AGENDA ITEM 4.a

SUBJECT: Discussion and input on proposed Planning Manager/Director determination on minor modifications to façade and material changes to Land Use Permit located at 1704 Mission Drive (APN 139-240-033).

HOTEL
1704 MISSION DRIVE
SOLVANG, CA 93463

COMMITTEE MEMBER COMMENT RECEIVED AFTER POSTING OF THE AGENDA

COTTAGE 2E AS-BUILT NORTH ELEVATION

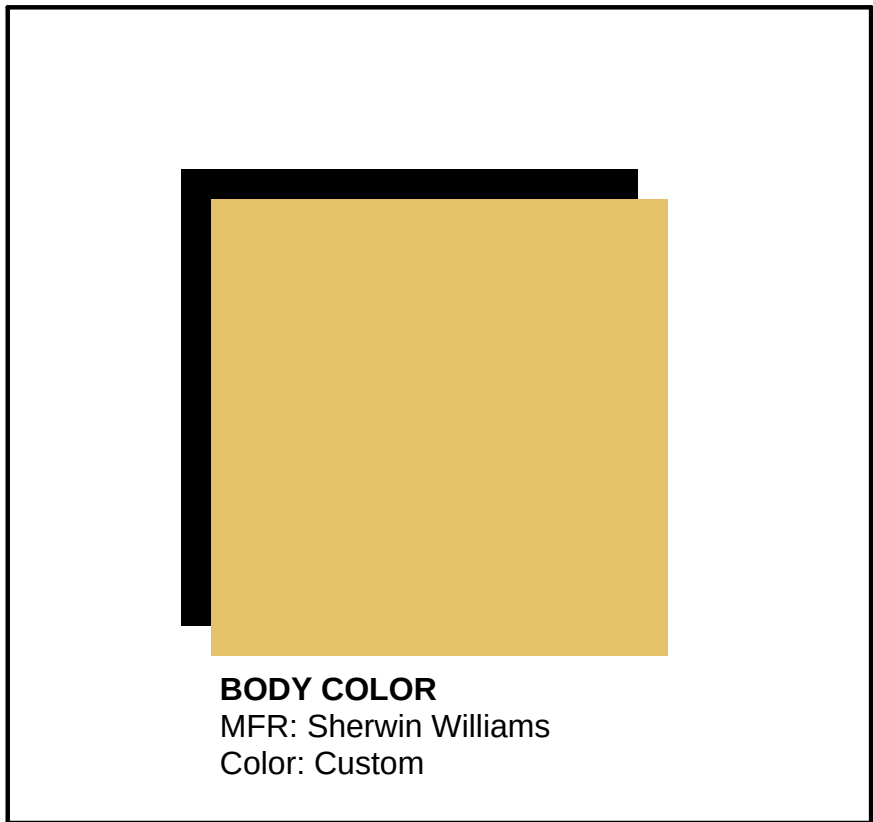
Approved Façade	Proposed Modifications	Director Recommendation
Unit 2		
 • Stucco wall • Stone chimney • Thatch roof • Half-timbers. • Proposed Color, “peppery” darker red hue	 • Proposed use of additional brick on west and north elevation • Additional half-timbering on east, west elevation • Use of half “logs” under the gable area. • Proposed custom color of dark yellow hue. BODY COLOR MFR: Sherwin Williams Color: Custom	The approved elevation included a mix of stone, half-timbers, stucco, and a faux thatch roof. The applicant has modified the approved elevation, and with use of half-timbers on elevations that is consistent with the “old world Danish/ northern European Design”. The applicant has included half-logs under the gable. The use of half-logs is not typical with Tudor, or Baroque design schemes of “Old World Danish”, however it is “Old World Northern European design, specifically farmhouses, cabins, and saunas found in Norway, Sweeden, and Finland. Some of the half-timbers are out of scale of the building and inconsistent with the design that was approved. The mix of brick and stucco does not lend to the color selection that the applicant proposes. Director Recommendation Based on the above analysis and pertinent goals and policies, the following are recommended: • All bricks be utilized on the west elevation (Alisal Road). • Half-logs to be eliminated and replaced with bricks, for consistency with traditional “Old World” Danish Design. • Reduce the number of half-timbers to bring the structure back to scale on the north/east elevation shown in red circles. • Maintain the originally proposed color of dark/reddish hue to match bricks either Carley’s Rose or Cajun Red.  #ad6f74  #85442a

COTTAGE 4D AS-BUILT NORTH WEST ELEVATION

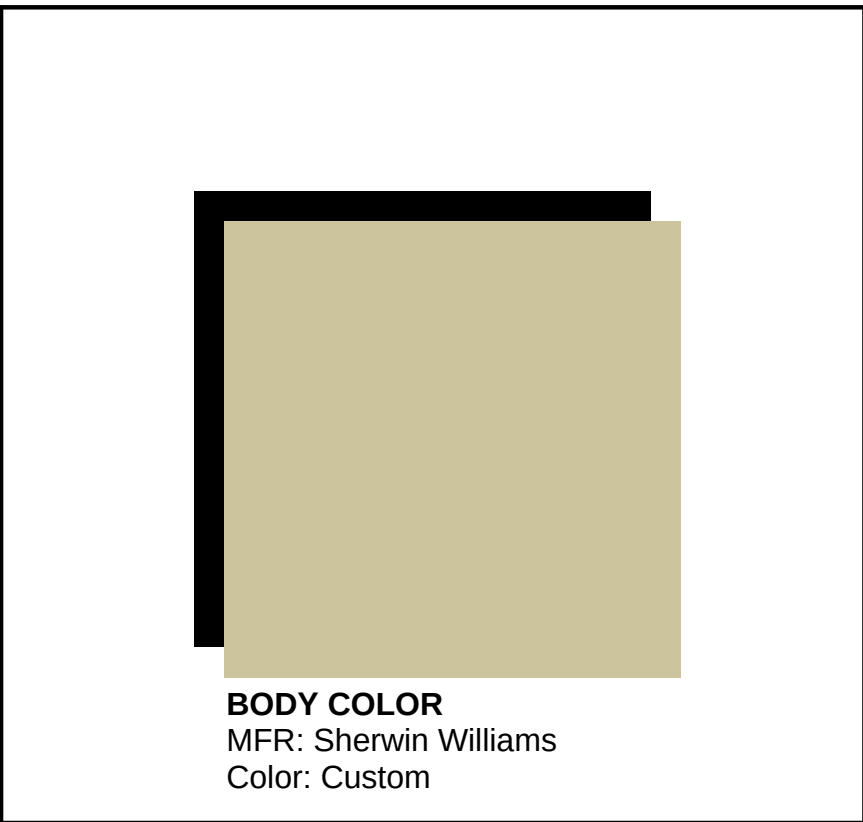
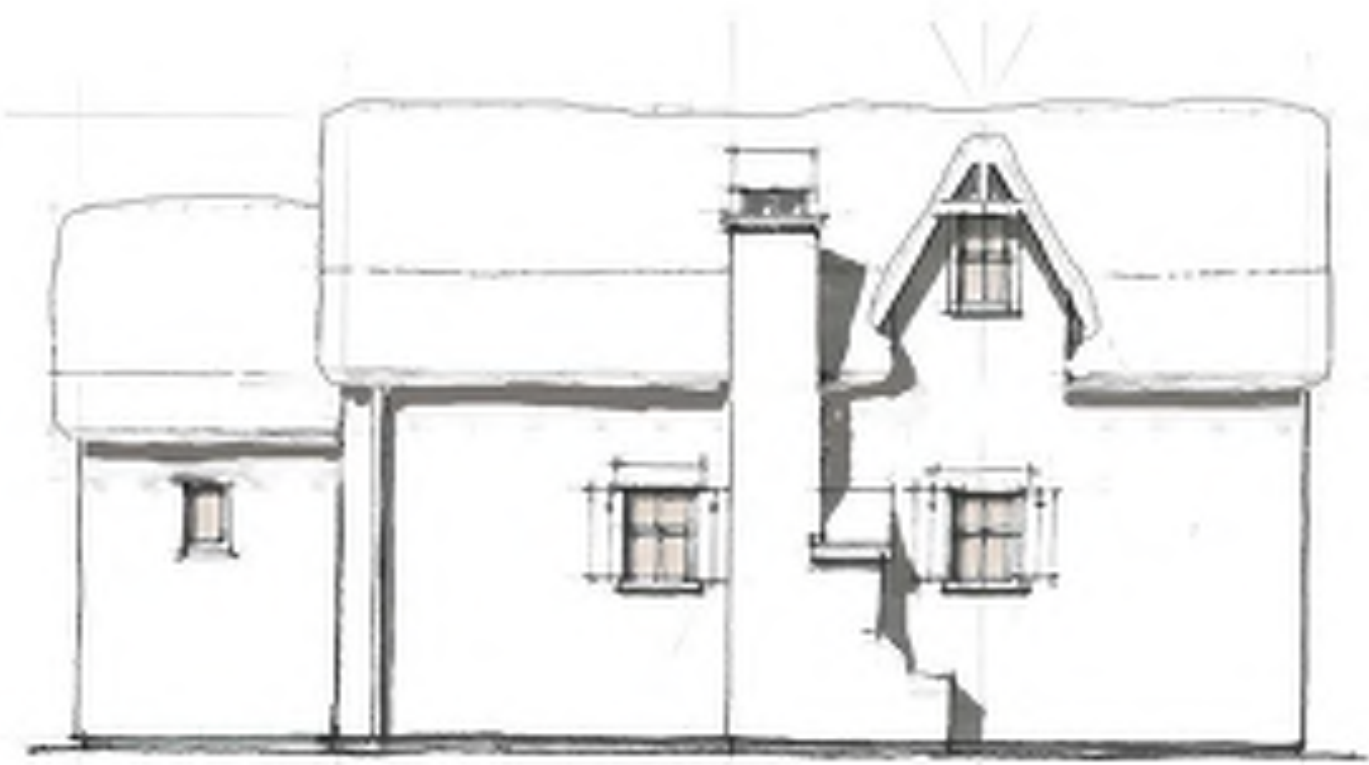
Approved Façade	Proposed Modifications	Director Recommendation
Unit 4		
   • Stucco wall • Stone chimney • Thatch roof • Half-timbers located near the edge of the gable. • Vintage Vessel Green to be utilized as primary color	   BODY COLOR MFR: Sherwin Williams Color: Custom • Stucco wall • Thatch roof • Additional half-timbers near the gables, and elimination of proposed patterns • Elimination of proposed front door portico • Custom muted yellow color	The applicant has modified the approved elevation with additional half-timbers. However, these half-timbers, particularly above the entry door where the portico was eliminated, do not emulate the authentic appearance and pattern of historic buildings, as outlined in the adopted Design Guidelines. These half-timbers should be eliminated. The applicant has completed additional wood detail utilizing log construction that is typical of “Old World Northern European” which does provide additional detail. The window on the North Elevation was moved and relocated more centered with the two windows closer to ground level. This provides additional natural light and is symmetrical with the elevation. Additional detailing along the eaves has been removed, but replaced with detailing in other portions of the structure. The proposed color change from a lighter yellow to a darker yellow, mute the darker half-timbers that are present, as well as the additional portico structure in the rear. Director Recommendation Based on the above analysis and pertinent goals and policies, the following is recommended: • Applicant remove half-timbers on north/entry elevation where it is circled in red. • Applicant utilize the custom color proposed for unit 2, on this unit, or the following:  BODY COLOR MFR: Sherwin Williams Color: Custom #ffdb68 Lemon Twist SW 6909 Goldfinch SW 6905 #fdb824

COTTAGE 5B AS-BUILT WEST ELEVATION

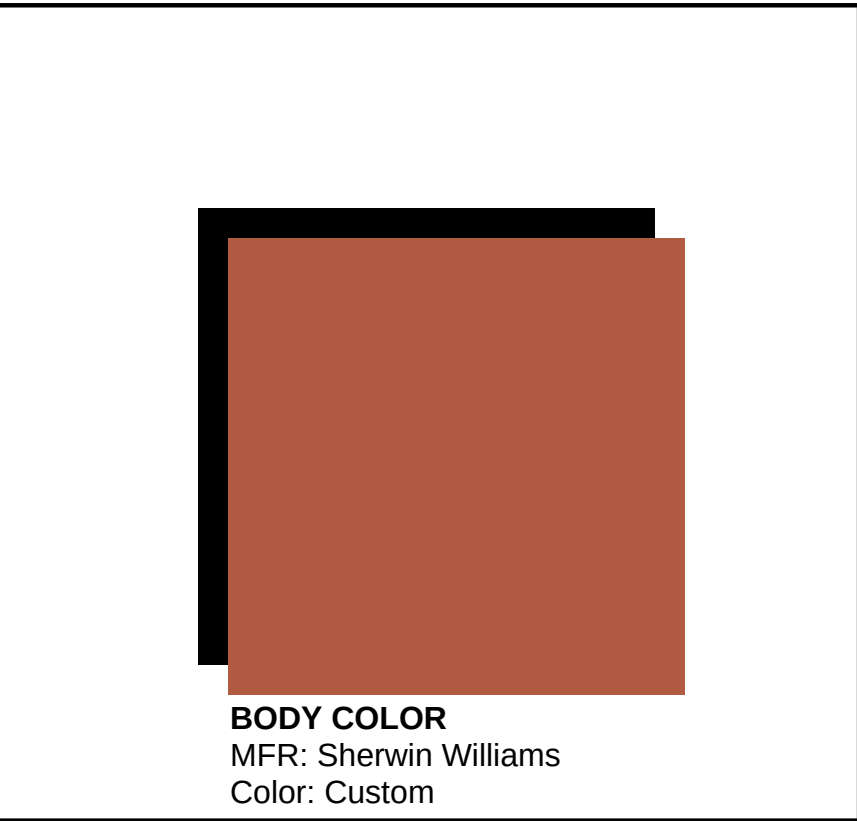
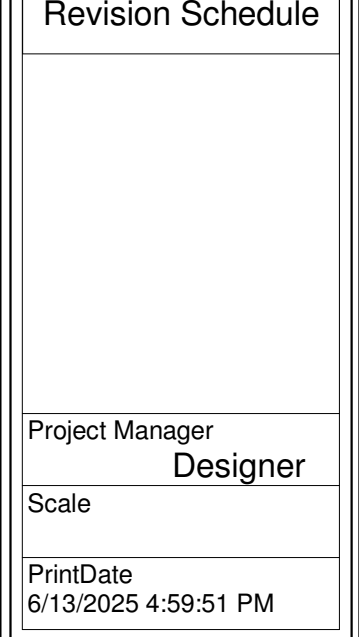
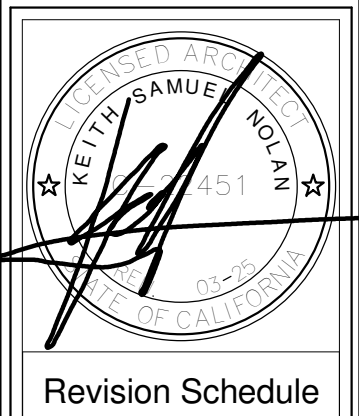
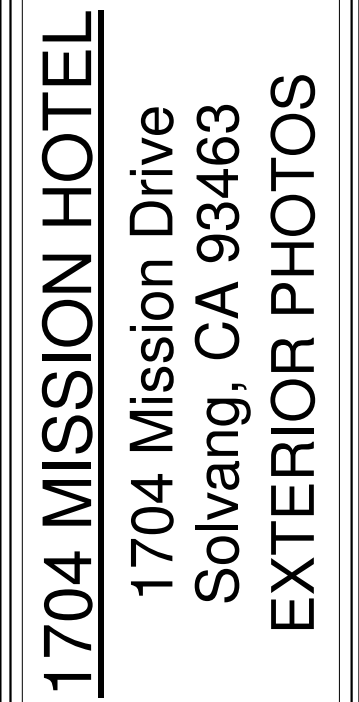
Approved Façade	Proposed Modifications	Director Recommendation
Unit 5		
 • Stucco wall • Stone chimney • Thatch roof • Half-timbers located on vertical west elevation. • Bracing Blue to be utilized as primary color • Shutters and other details	 • Elimination of shutter details • Elimination of Portico on South elevation • Elimination of Stone Chimney • Half-timbers utilized throughout all elevations. • Redish color for primary façade	The applicant has modified the approved elevation, with additional half-timbers that are to scale and utilized on all elevations. While some of the patterns are close together, these patterns are symmetrical and consistent with patterns completed that simulate “authentic” design. The applicable adopted documents do not define elements of Northern European design, therefore, it is considered consistent with the intent of the Community Design Element from 1989. Director Recommendation Based on the above analysis and pertinent goals and policies, the following is recommended: • Applicant proposed modifications, including the additional half-timbers which are consistent with adopted documents at the time of entitlement approval. Proposed modifications can move forward.

COTTAGE 6C AS-BUILT WEST ELEVATION

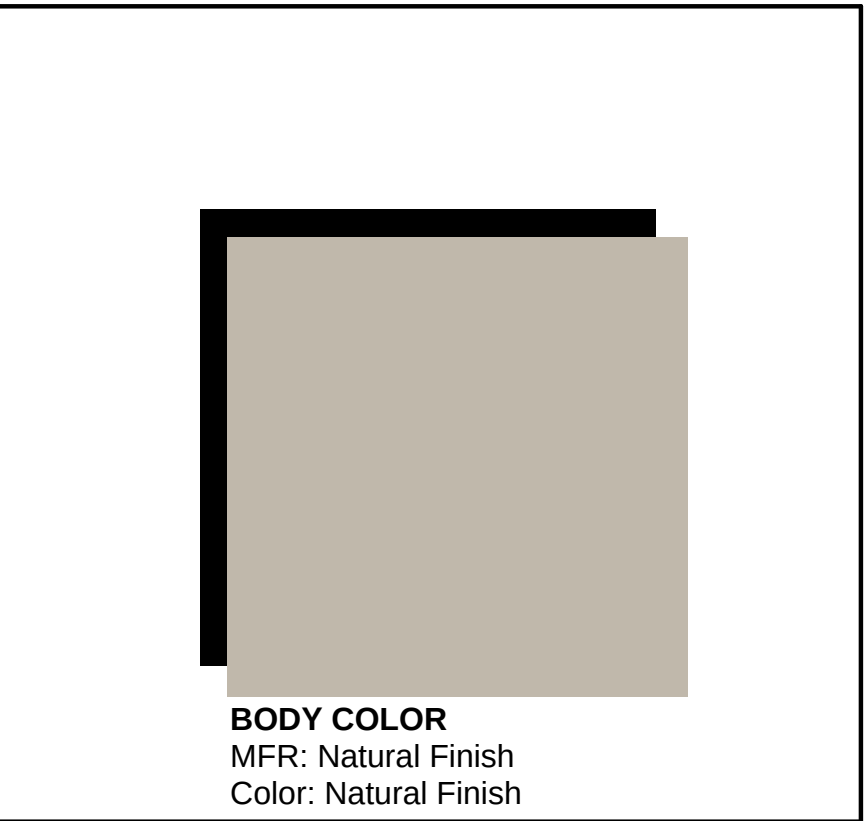
Approved Façade	Proposed Modifications	Director Recommendation
Unit 6		
 • Stucco wall • Thatch roof • Stone utilized on portions of the facades • Shutters/faux flue detail • Peppery to be utilized as primary color	  BODY COLOR MFR: Natural Finish Color: Natural Finish • Stucco wall • Thatch roof • Addition of Stone on west elevation • Use of half-timbers • Elimination of shutters and faux flue • Addition of half “logs” on north elevation • Change of color to “natural” finish	The approved elevation included a mix of stone, half-timbers, stucco, and a faux thatch roof. The applicant has modified the approved elevation with the use of half-timbers on elevations that is consistent with the “Old World Danish/ Northern European Design”. The applicant has included half-logs on the entire elevation. The use of half-logs is not typical with Tudor, or Baroque design schemes of “Old World Danish”, however it is “Old World Northern European” design. Specifically; farmhouses, cabins, and saunas found in Norway, Sweeden, and Finland. Stone is not typical of “Old World Danish”, however it is considered “Old World Northern European”, therefore it is consistent with the previous General Plan, Community Design Guidelines, and adopted Design Guidelines. The elimination of the shutters and faux flue are mitigated with the addition of the half-timbers and other details. The proposed color “natural finish” is a color inconsistent with the “Old World Danish” color, and it is recommended to utilize a different color shade in the orange, reds, or brown hues. Director Recommendation Based on the above analysis and pertinent goals and policies, the following are recommended: • Half-logs to be eliminated and replaced with bricks, for consistency with traditional “Old World” Danish Design. • Proposed new colors from the following below:  Smoky Salmon SW 6331 #dfb9a9  Chaise Mauve SW 6016 #bfb3b3  Cavern Clay SW 7701 #ae6d51

COTTAGE 8C AS-BUILT WEST ELEVATION

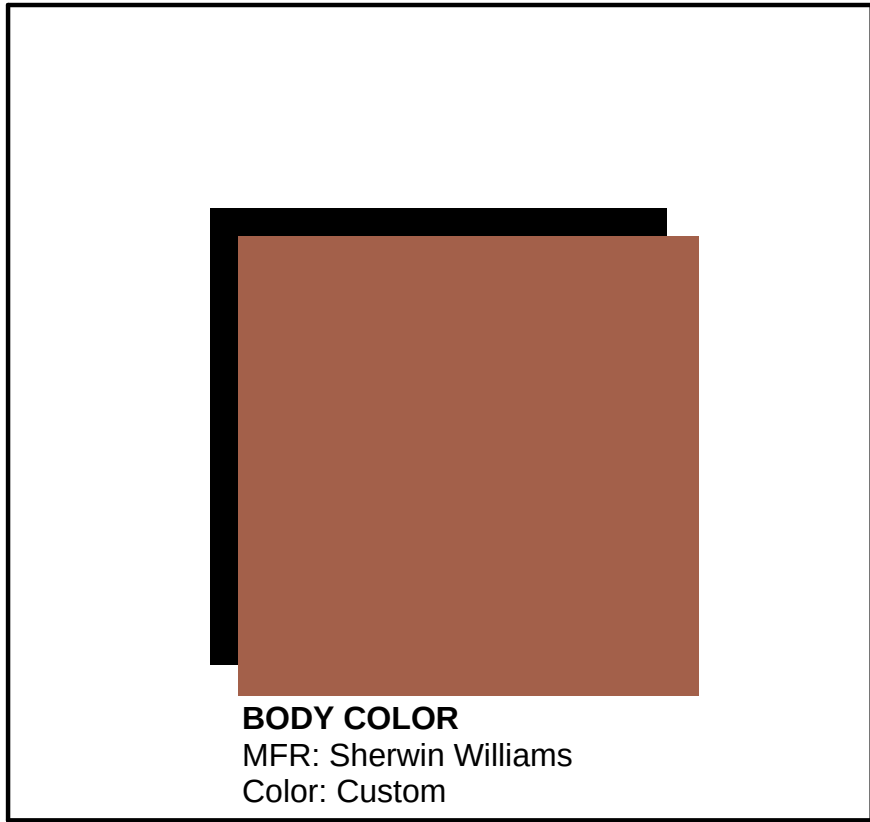
Approved Façade	Proposed Modifications	Director Recommendation
Unit 8		
 • Stucco wall • Thatch roof • Stone utilized on chimney • Shutters/faux flue • Bracing Blue to be utilized as primary color	  • Elimination of proposed stucco wall • Elimination of stone chimney • Elimination of shutters /faux flue • Addition of brick throughout all elevations • Change of façade color to match darker reddish hue bricks • Addition of half-timbering	Brick facades were utilized in “Old World Danish” design, along with half-timbers. The half-timbers are painted in a dark hue. These design elements are consistent with adopted design documents in effect at the time of entitlement. Director Recommendation Based on the above analysis and pertinent goals and policies, the following is recommended: • Applicant’s proposed modifications, including the additional use of half-timbers and brick is consistent with adopted documents at the time of entitlement approval. Proposed modifications can move forward.

COTTAGE 9 AS-BUILT WEST & NORTH ELEVATION

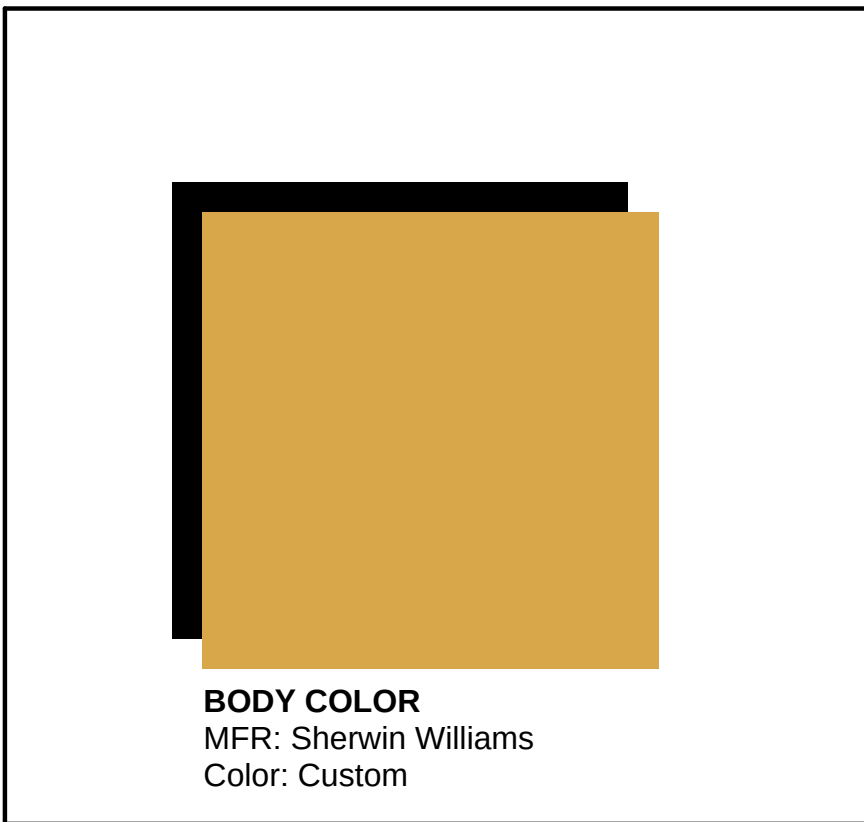
Approved Façade	Proposed Modifications	Director Recommendation
Unit 9		
 • Stucco wall • Thatch roof • Stone utilized on chimney • Use of half-timbers near gable • Use of Sunrise, light yellow color	 • Additional use of half-timbering on all elevations • Change of façade color to darker yellow • Elimination of dormers • Elimination of upper windows	The applicant has modified the approved elevation, with additional half-timbers, however, these timbers do not emulate the authentic appearance and pattern of historic buildings as these patterns contains curves and other design elements that do not mimic natural wood. These timbers should be eliminated as they create too many patterns and curvature. The applicant has eliminated dormers and windows. With the recommended elimination of half-timbers, use of window planter boxes are recommended to be brought forth from the original design. Director Recommendation Based on the above analysis and pertinent goals and policies, the following is recommended: • Half-timbers circled in red and any other elevations that create too many patterns and curvature should be eliminated. • Addition of planter boxes under windows to enhance the façade.
